6. COA-084318-2021

1634 West Grace Street

STAFF REPORT

Replace slate tile with synthetic slate.

Figure 1. 1634 West Grace Street, as viewed from the sidewalk

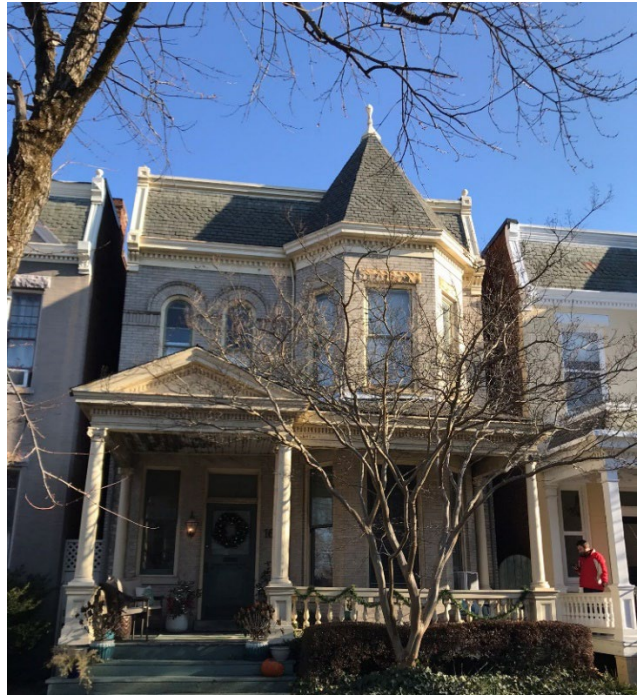
Staff finds the false mansard roof is a character-defining feature and recommends denial of its replacement with synthetic slate. If the roof is beyond repair, staff recommends the applicant work with staff to gain administrative approval for the in-kind replacement of the roof, to match the existing materials and design.

Staff finds that the front porch roof is highly visible from the street and recommends denial of the installation of synthetic slate on the front porch roof. Staff finds that the proposed Eco Star majestic slate does not effectively replicate the appearance of historic slate in this highly visible location. In addition, staff has concerns regarding the durability of the synthetic slate, which can be easily damaged, which in turn would further reduce its resemblance to historic slate.

- Staff recommends **denial** of the replacement of the front porch and false mansard roofs with synthetic slate as they are highly visible and the proposed synthetic slate will not effectively replicate the appearance of the historic slate roof.
- Staff recommends the applicant work with staff to obtain administrative approval for the repair work required for the front porch.
